Independent Planning Commission

**Re: Gunnedah Solar Farm, Ref SSD8685**

**Figure 4** | Change in floodwater depth at perimeter incorporating fencing configuration 5

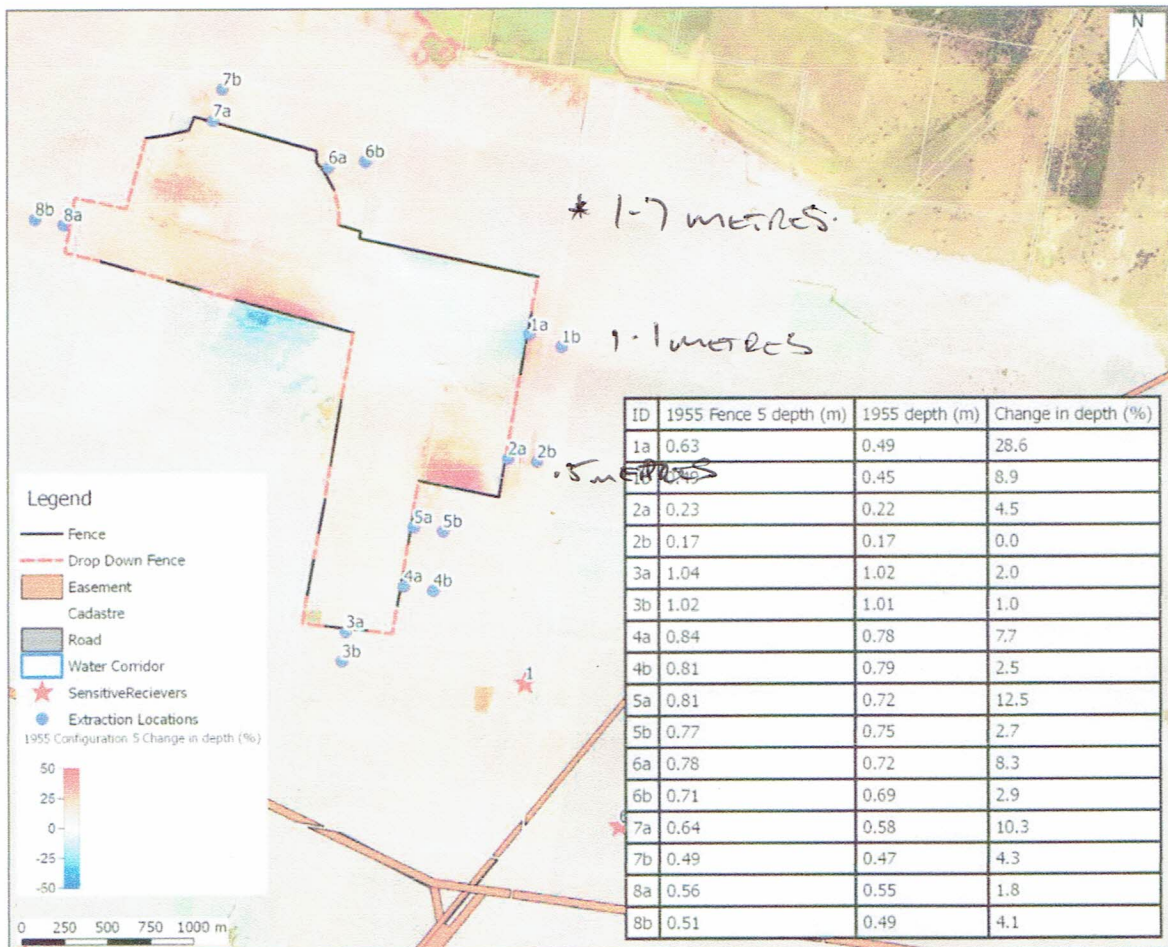
Interpolated 1955 flood level at site (VP1) is 270.1 m, as quoted on detail site plan proposed residence & pad completed by Stewart Surveys and documented heights from Monteath and Powys flood survey on RL's compared to Figure 4, page 15 of the Gunnedah Assessment Report as detailed below:

**Point 1 B 269 m**

270.1 minus 269 = 1.1 m not .45 m

**Point 2 B 269.6 m**

270.1 minus 269.6 = .5 m not 0.17 m

Assuming these two points differ by 500 to 600 mm the points in figure 4 would differ a similar amount, for example **Point 3A = 1.64 not 1.04 m.**

These huge differences in flood measurements would have an enormous impact on flood level heights and redirection of floodwater.

My concerns are that the flood study undertaken by Photon Solar, are not consistent with the flood studies provided to us by First Solar (Monteath & Powy's). It's appears to be misleading information as the flood levels quoted by Photon are approximately 600 mm lower than the flood studies provided to us by First Solar and also Stewart Surveys.

# FIRST SOLAR FLOOD STUDY SURVEY COMPLETED BY MONTEATH + POWYS

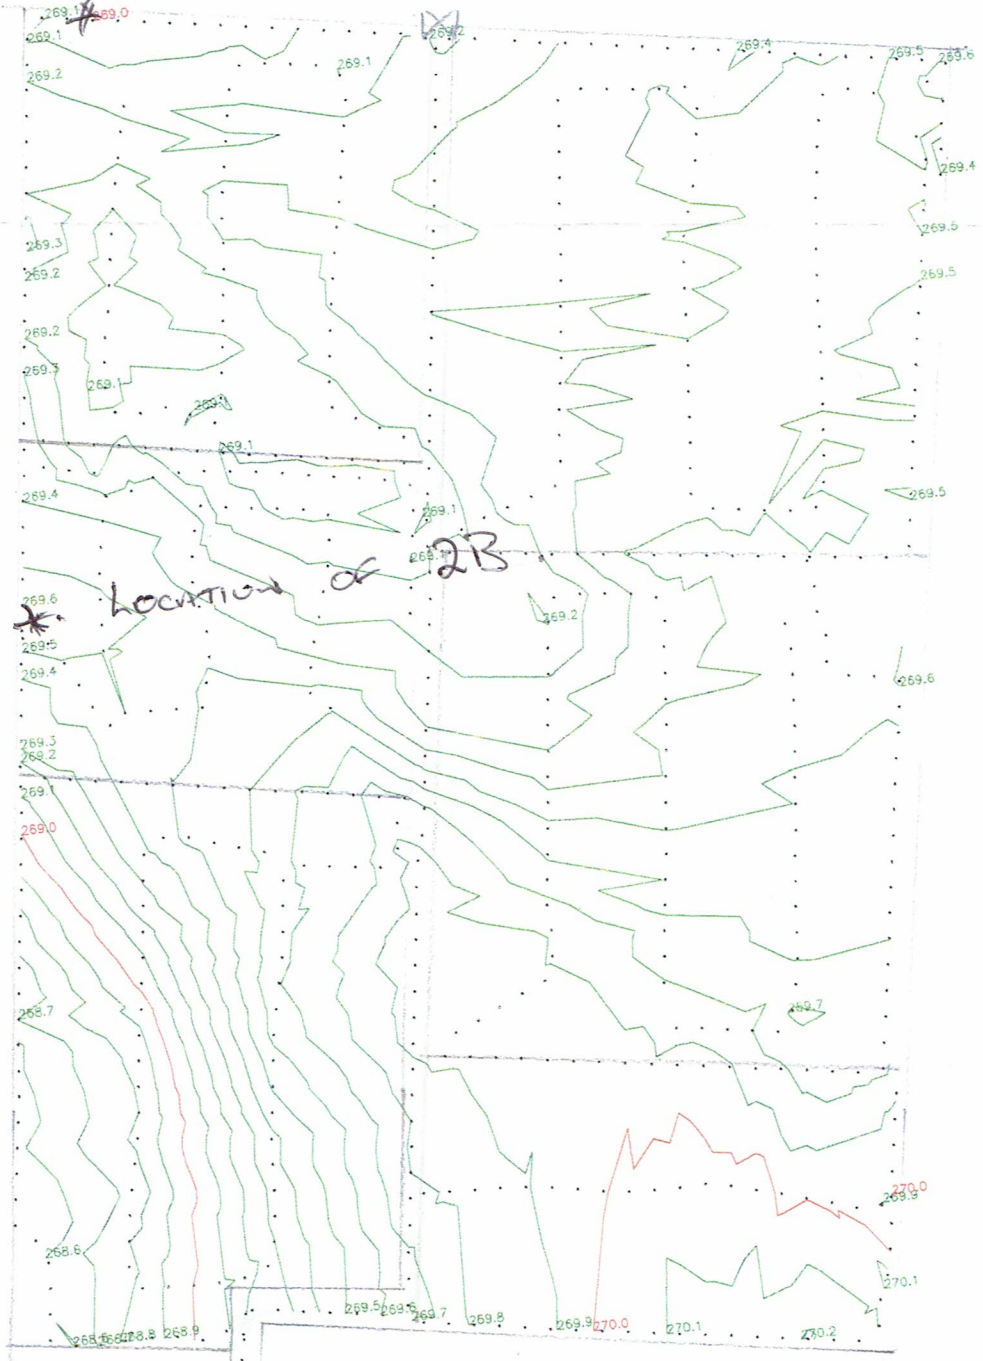
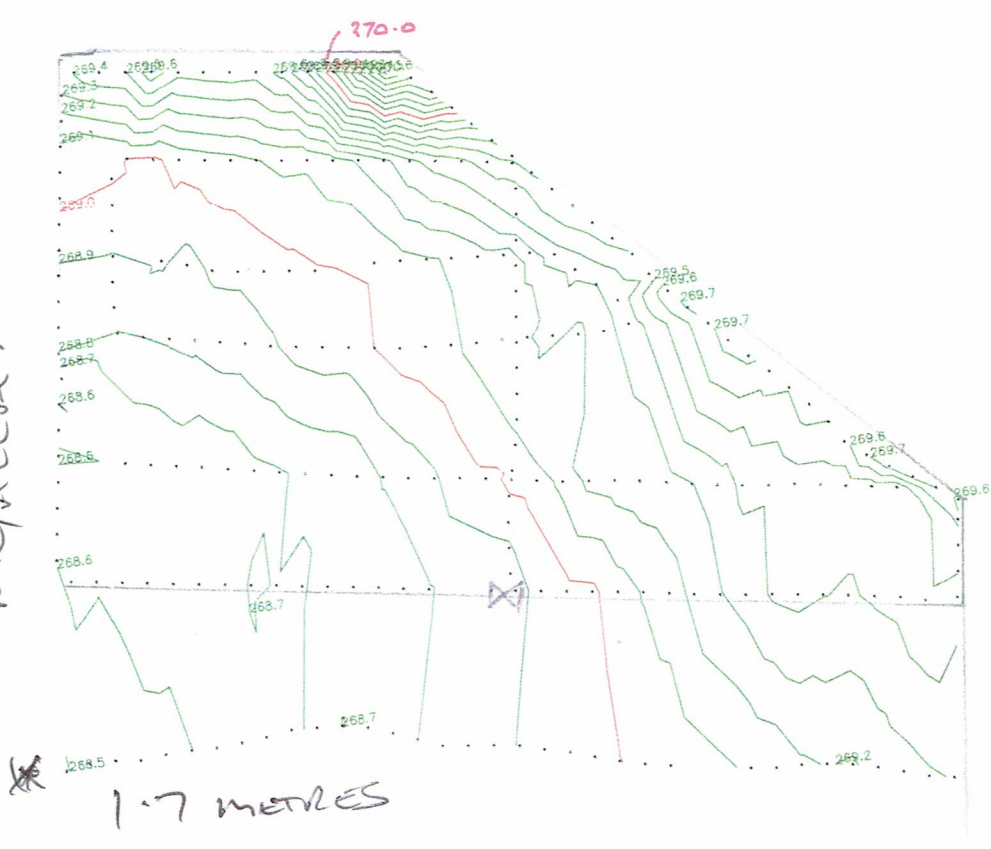
Due to the site being on a flood plain First Solar completed a flood study which involved surveying the complete site of RL's to give an indication of actual flood depths (copy attached "Monteath and Powy's Pty Ltd Study Survey"), in a 1 in 100 year flood which was much higher than expected.

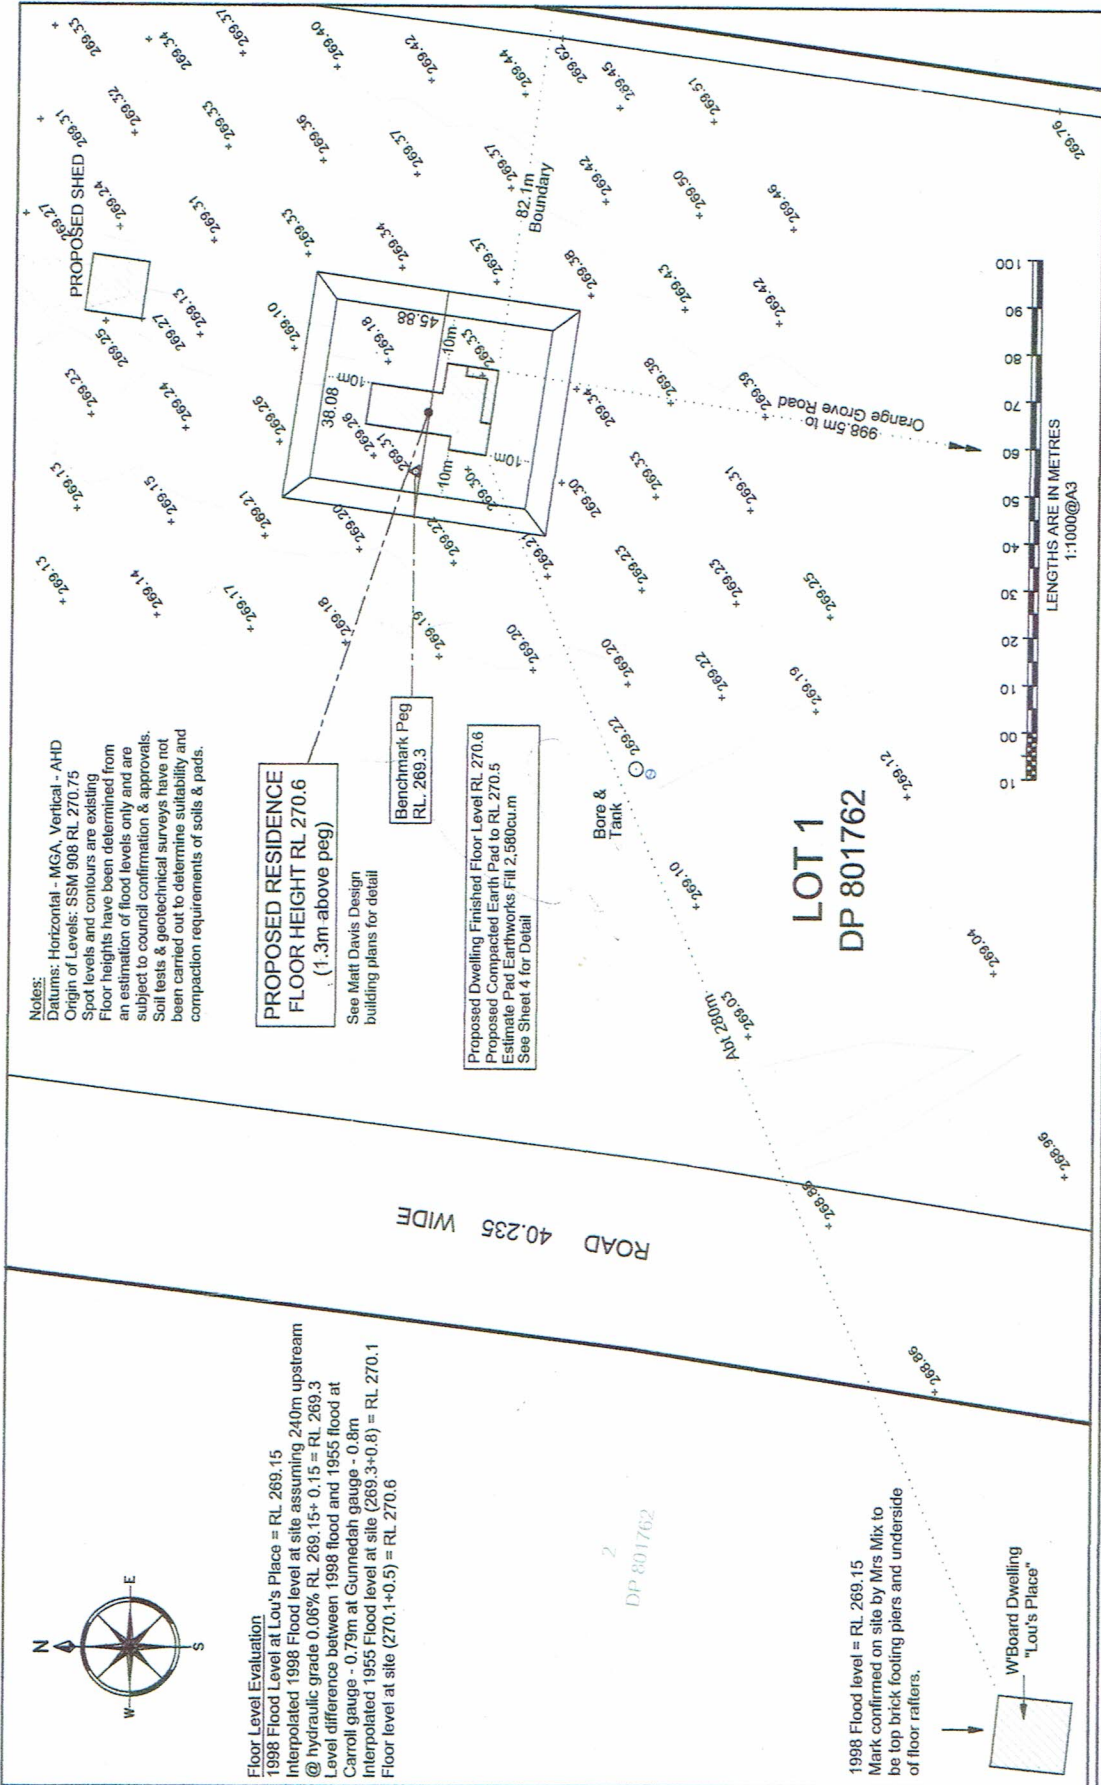
In 2006 we built a new house at the southern end of our property (VP1). This site was surveyed for a 1 in 100 year flood level by Stewart Surveys (detail site plan proposed residence & pad) and this plan was used as a reference to show the actual depths in conjunction with the surveying of RL's from First Solar's flood study (completed by Monteath and Powys Surveyors).

Flood level at Myalla house levee bank is 1.4 metres as reference was used from our house site survey in conjunction with Stewart Surveys to build the bank. The levee bank and house floor level had to be elevated to 1.9 metres due to 1 in 100 year flood levels.
